AUDUBON COVE SUBDIVISION

APPLICATION NUMBER 15 DATE February 5, 2004

REQUEST Subdivision

DETAIL SITE PLAN

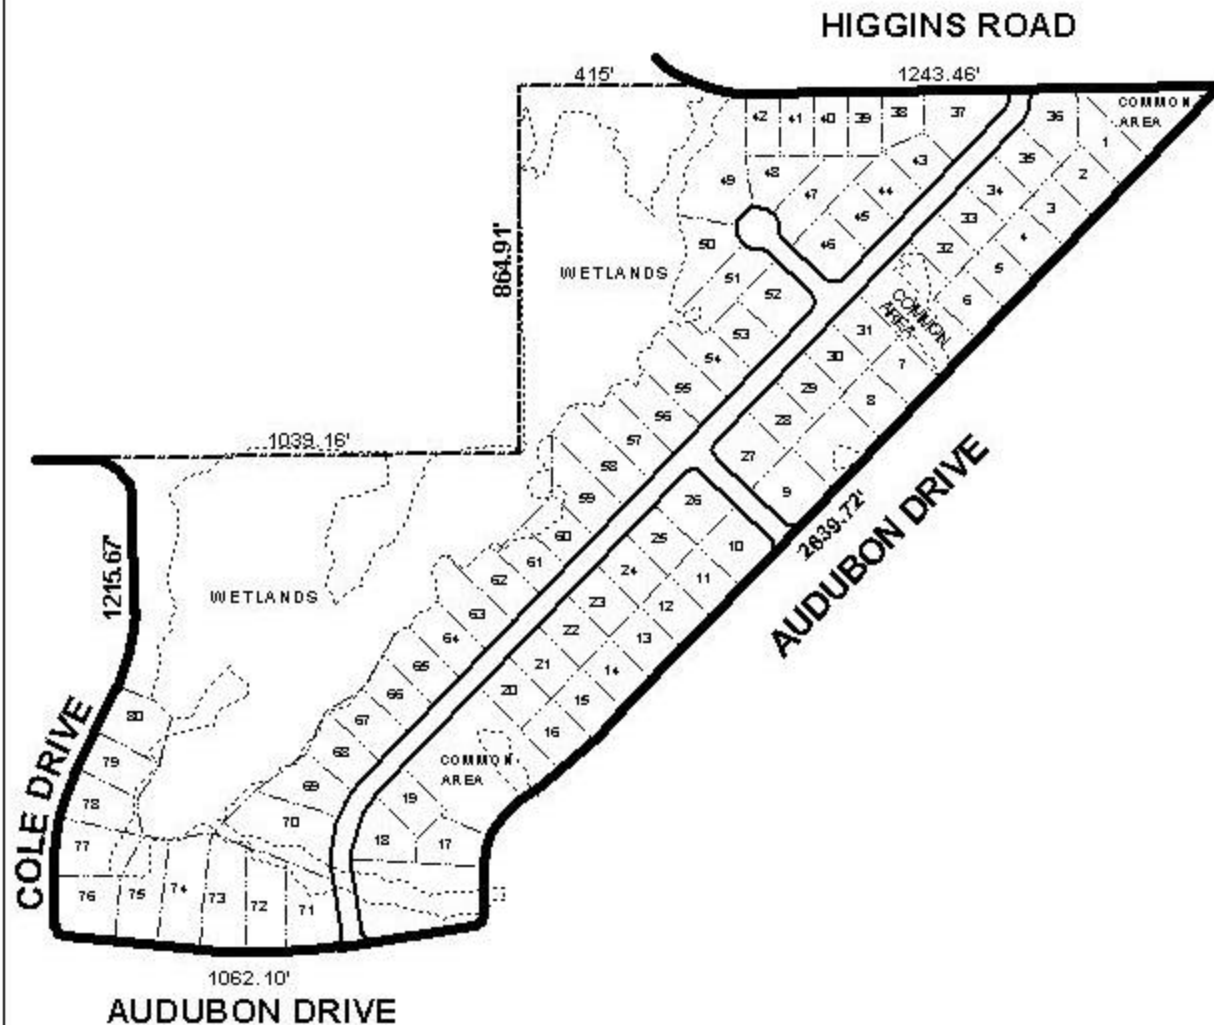
There are wetlands located on the site, thus the area could be considered environmentally sensitive; therefore, the approval of all federal, state and local agencies would be required.

The site also has common areas and the use of these common areas should be shown on the final plat. Additionally, the placement of a note on the final plat stating that the maintenance of the common areas shall be the responsible of the property owners, should be required.

The proposed street is long and although there are intersecting streets, some form of traffic calming at the intersections is necessary, and should be coordinated with and approved by Traffic Engineering and Urban Development prior to the recording of the final plat.

With modifications, the plat will meet the minimum requirements of the Subdivision Regulations and is recommended for Tentative Approval subject to the following conditions: 1) the approval of all applicable federal, state and local agencies; 2) that the use of the common areas be labeled on the final plat, with a note stating that the maintenance thereof is the responsibility of the property owners; 3) the provision of traffic calming at the intersections on the new street(s); and 4) full compliance with the City Engineering Comments (must comply with all stormwater and flood control ordinances; any work performed in the right of way will require a right of way permit; developer must provide an approved outfall into a City of Mobile maintained system at any point of discharge where one does not exist; this development contains one or more points of discharge where an acceptable outfall does not exist, thus, the developer will be required to provide outfall approved by the City Engineer).
